STATE OF CONNECTICUT
CONNECTICUT SITING COUNCIL

IN RE:	:	
	:	
APPLICATION OF CELLCO PARTNERSHIP	:	DOCKET NO. 494
D/B/A VERIZON WIRELESS FOR A	:	
CERTIFICATE OF ENVIRONMENTAL	:	
COMPATIBILITY AND PUBLIC NEED FOR	:	
THE CONSTRUCTION, MAINTENANCE	:	
AND OPERATION OF A WIRELESS	:	
TELECOMMUNICATIONS FACILITY OFF	:	
CHESTNUT HILL ROAD, WOLCOTT,	:	
CONNECTICUT	:	NOVEMBER 13, 2020

**UPDATED RESPONSES OF CELLCO PARTNERSHIP D/B/A VERIZON WIRELESS
TO CONNECTICUT SITING COUNCIL PRE-HEARING QUESTIONS, SET ONE**

Existing Verizon Wireless 850 MHz Coverage
Wolcott, Connecticut and Surrounding Area
(*Map Scale is 1:18,000)

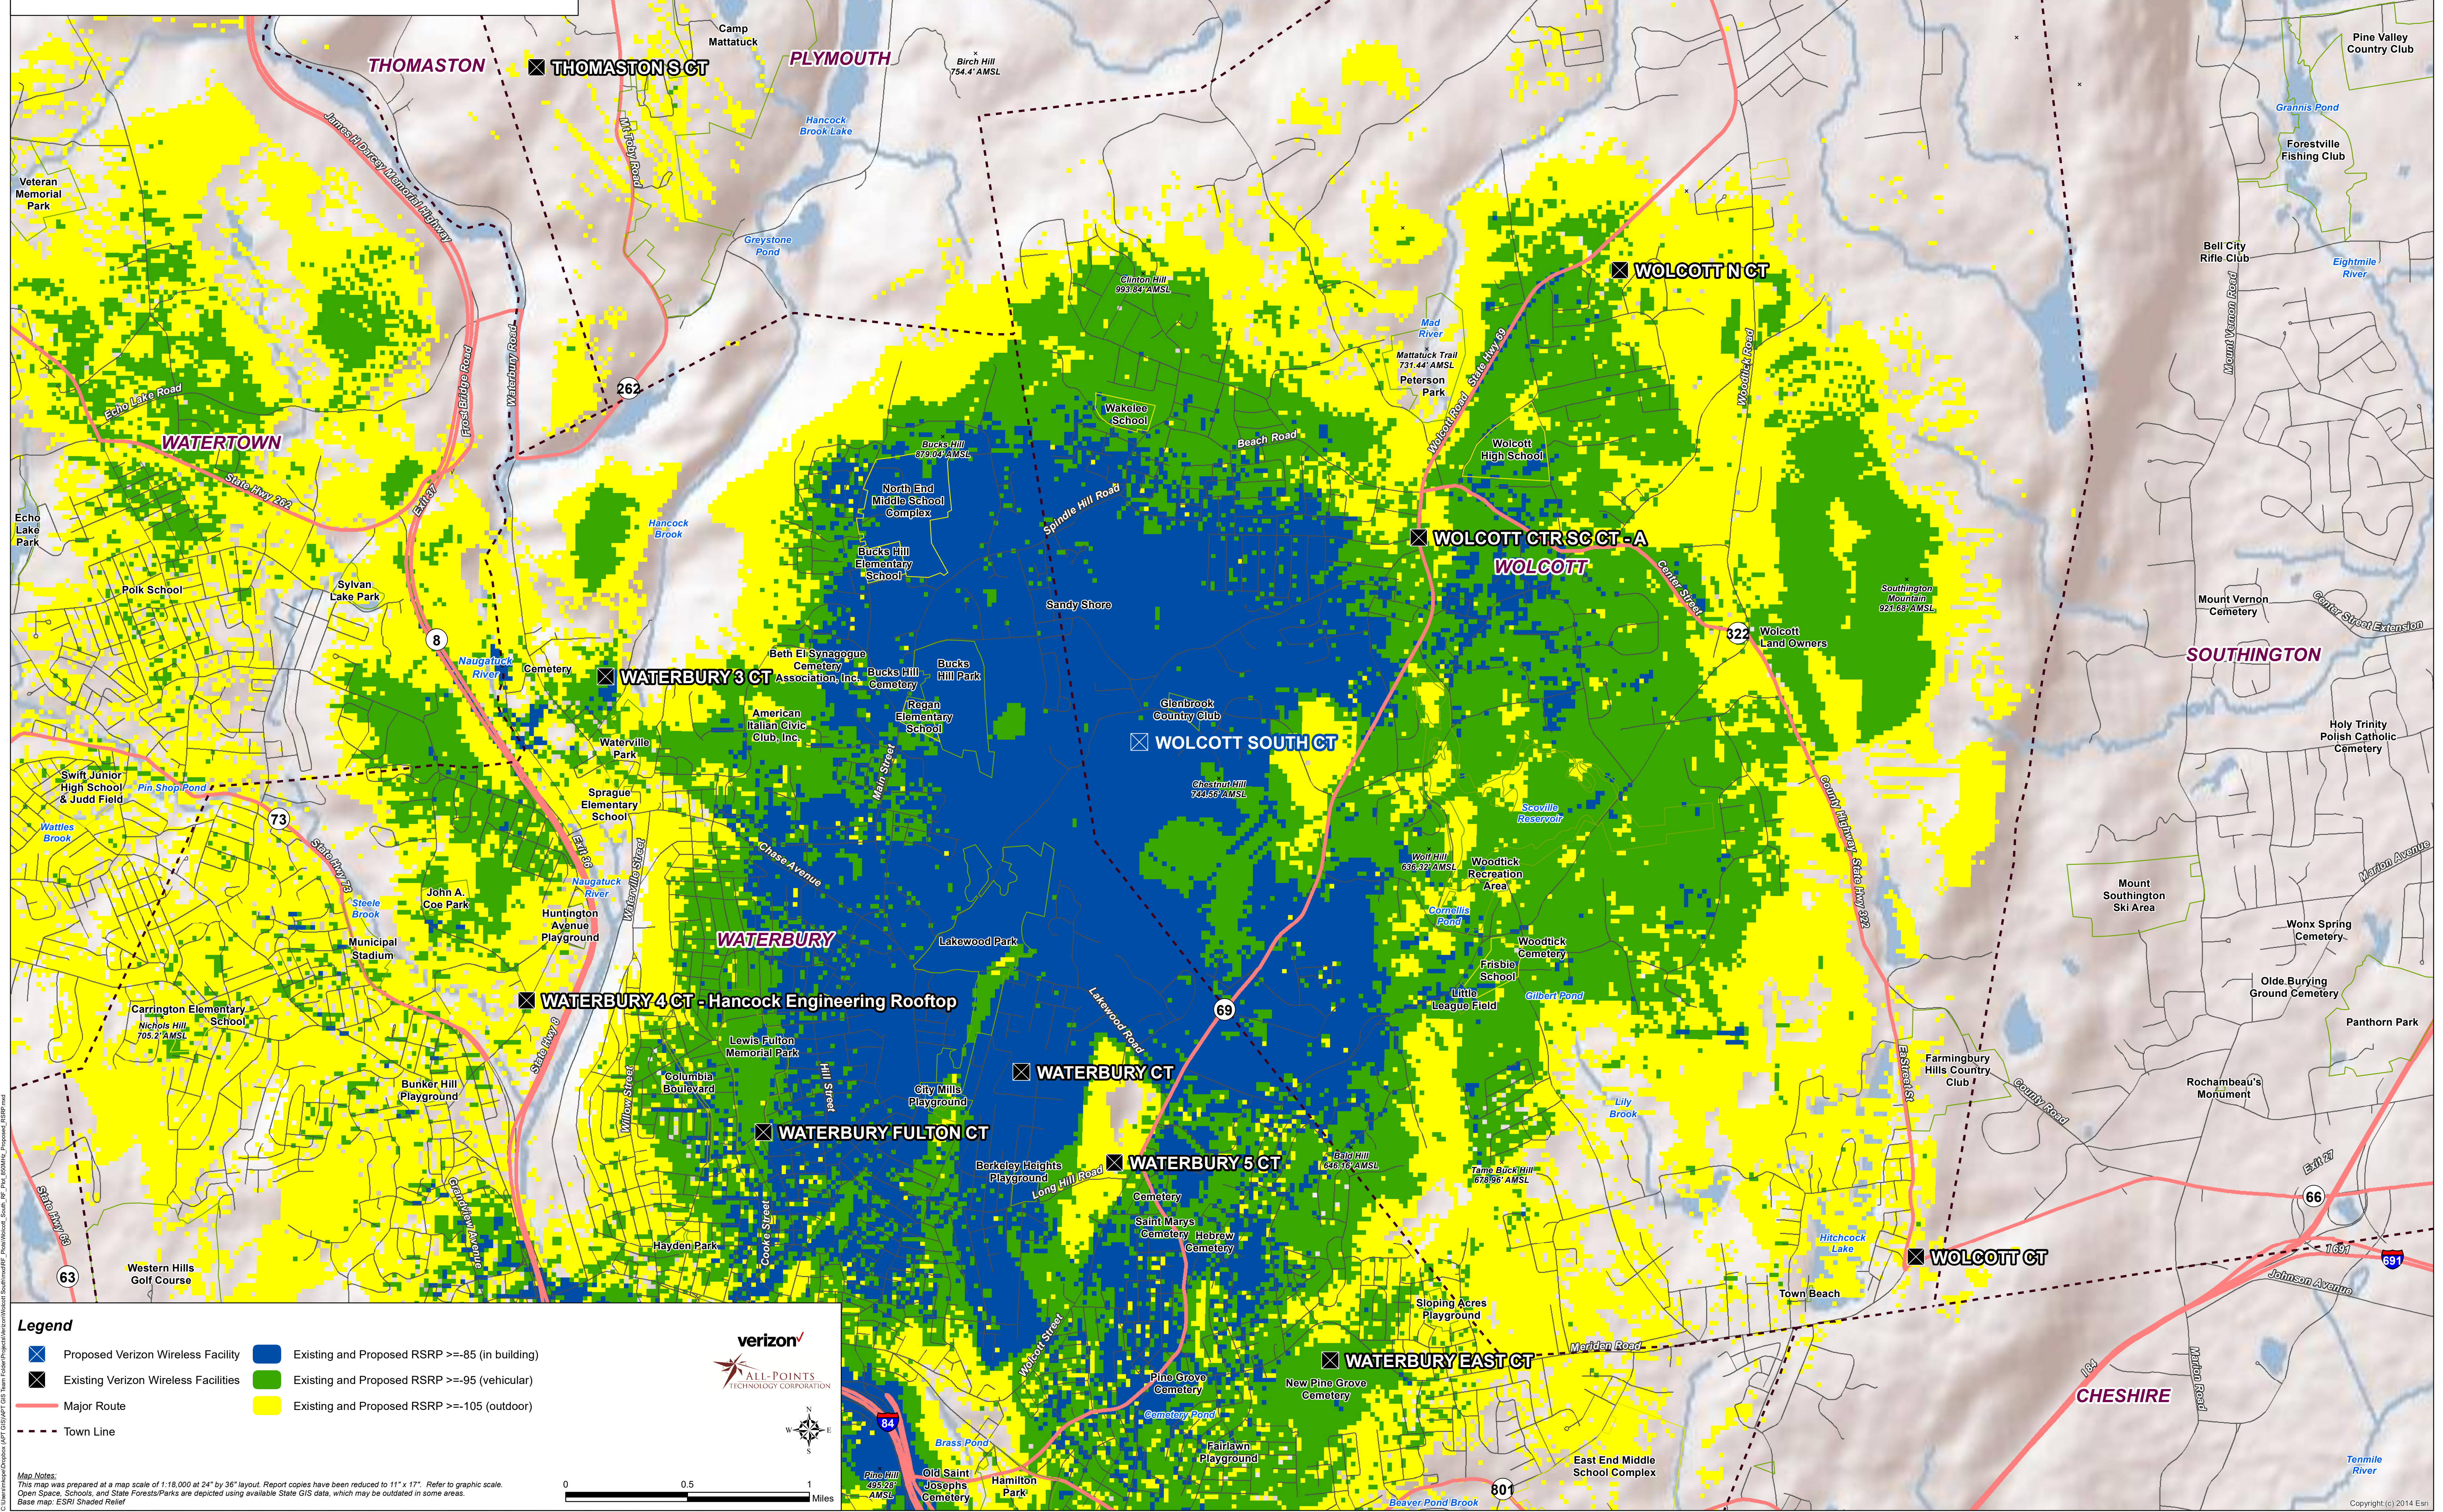
Referencing Tab 6 of the Application, Coverage Maps, please provide the existing 850 MHz coverage map. Also, provide the existing and proposed 850 MHz coverage map.

The 850 MHz coverage maps requested are included in Exhibit 4.

Viewshed Analysis Map
 Proposed Wireless Telecommunications Facility
 Wolcott South CT
 Chestnut Hill Road
 Wolcott, Connecticut

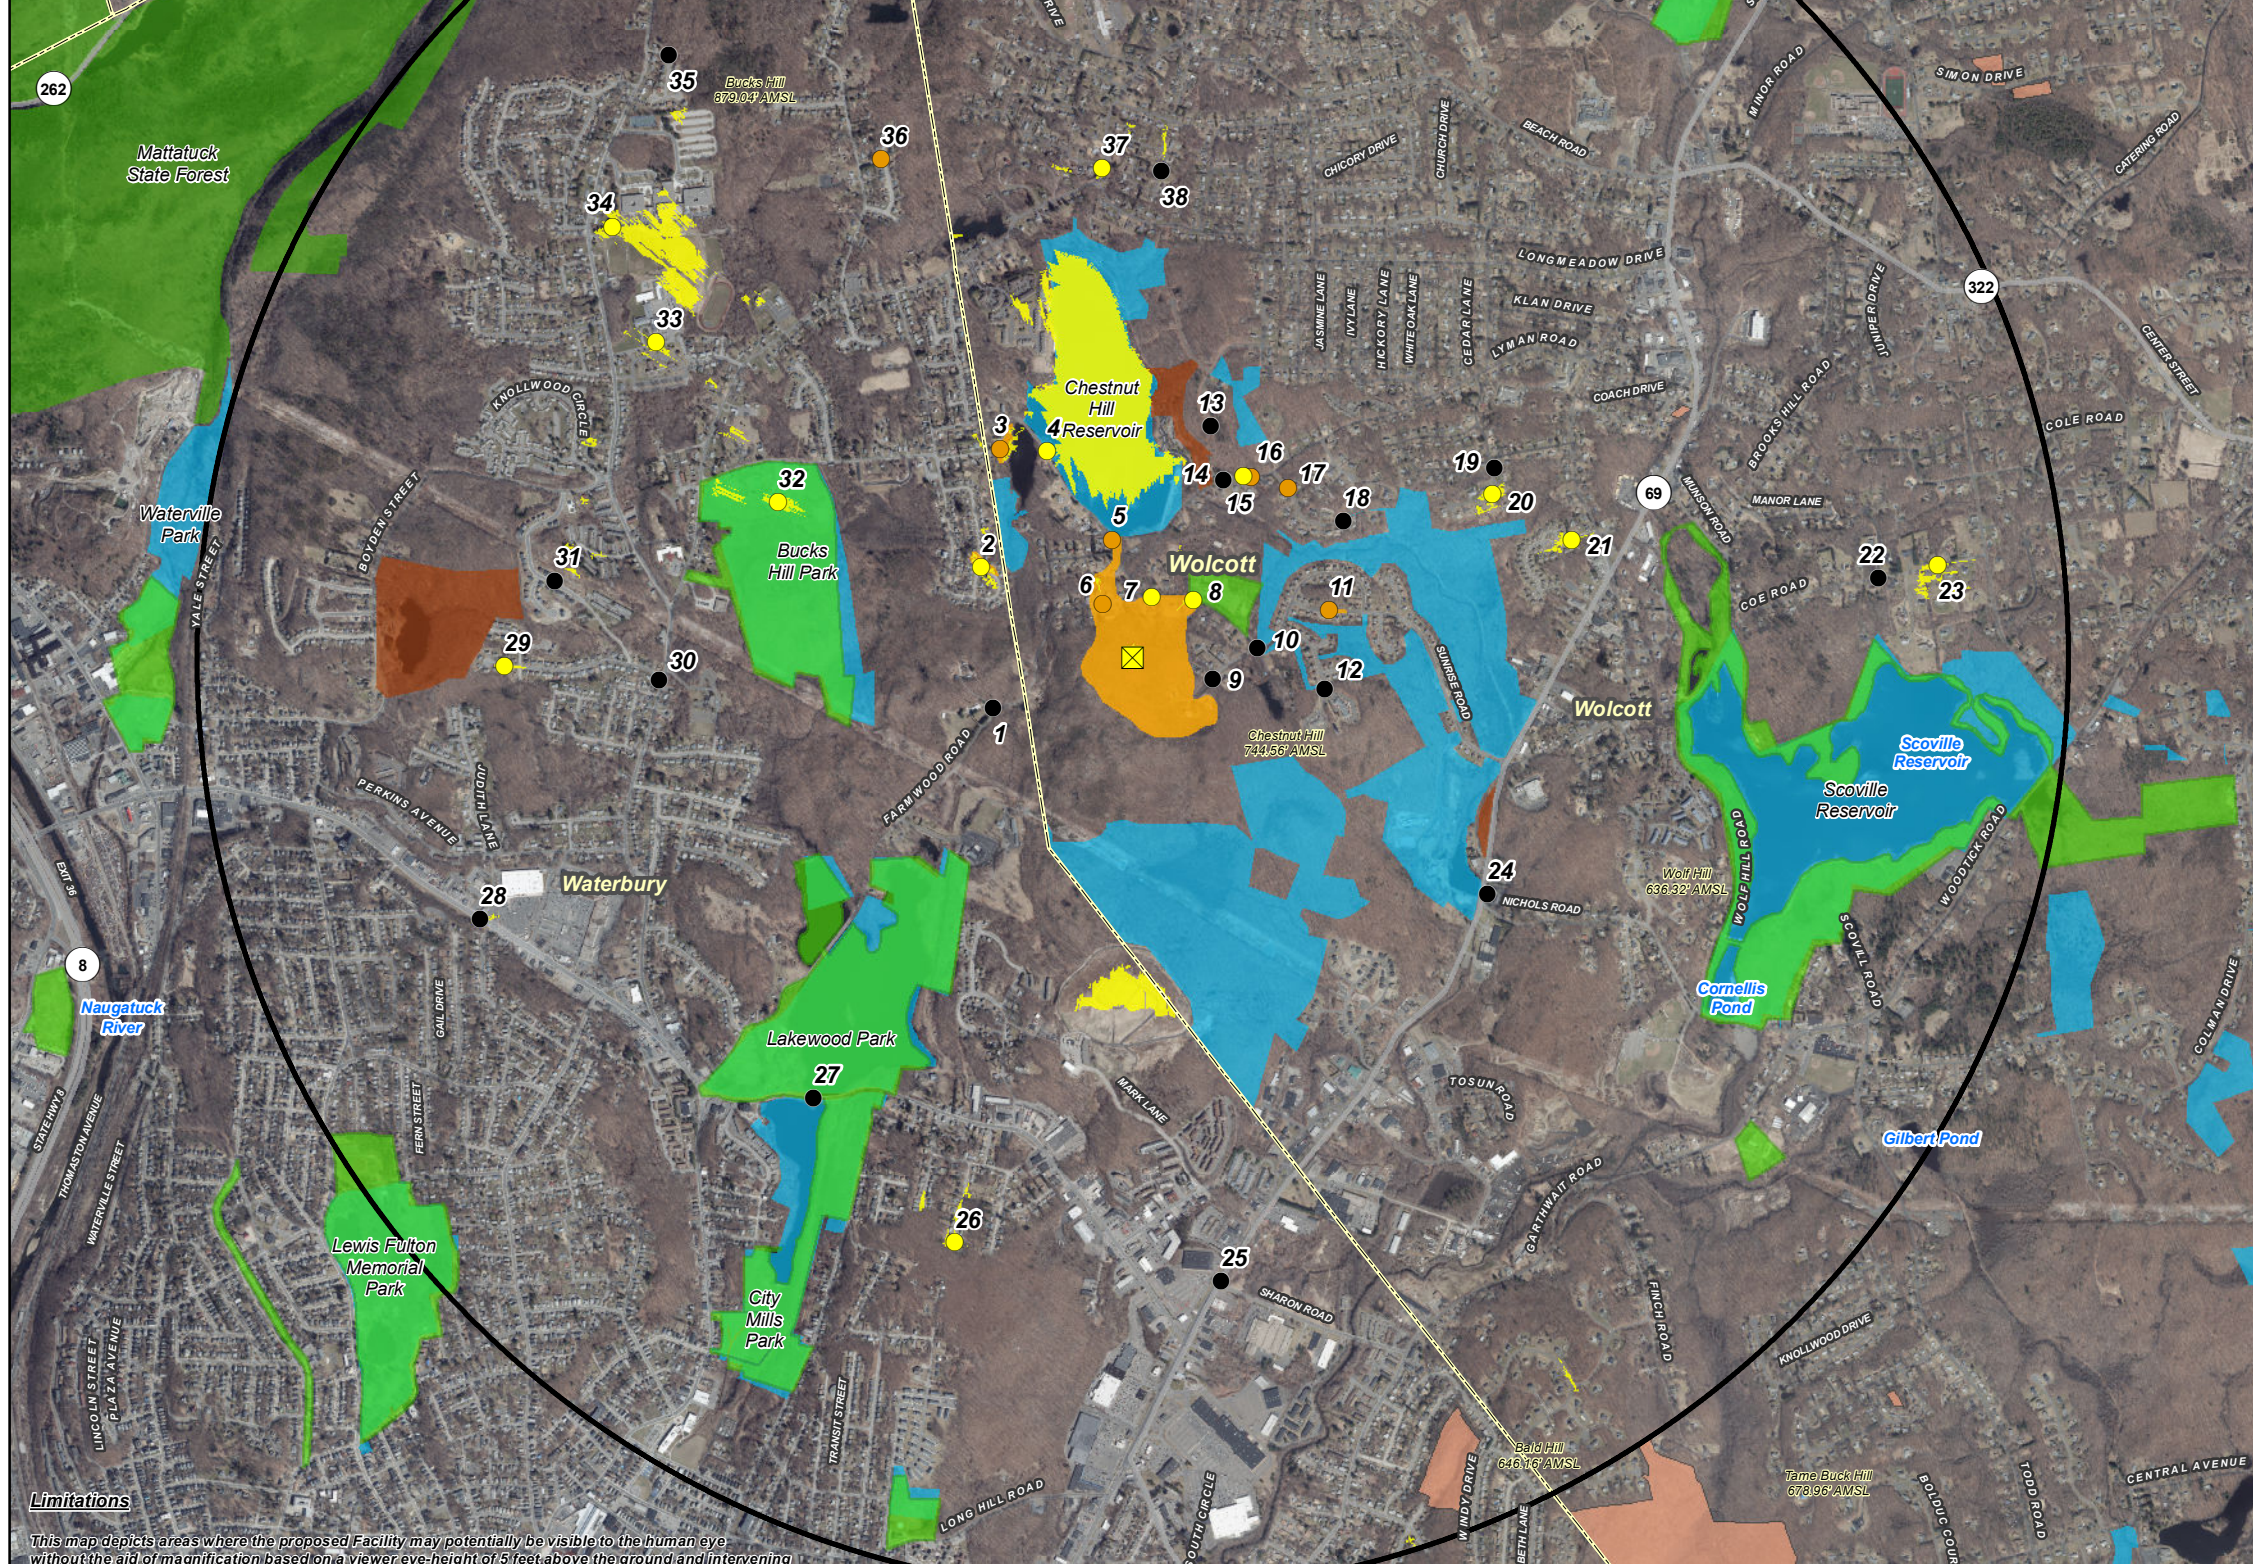
Referencing page 6 of the Visual Assessment of the Application, Cellco states “As presented on the attached viewshed maps...” Please provide such viewshed maps.
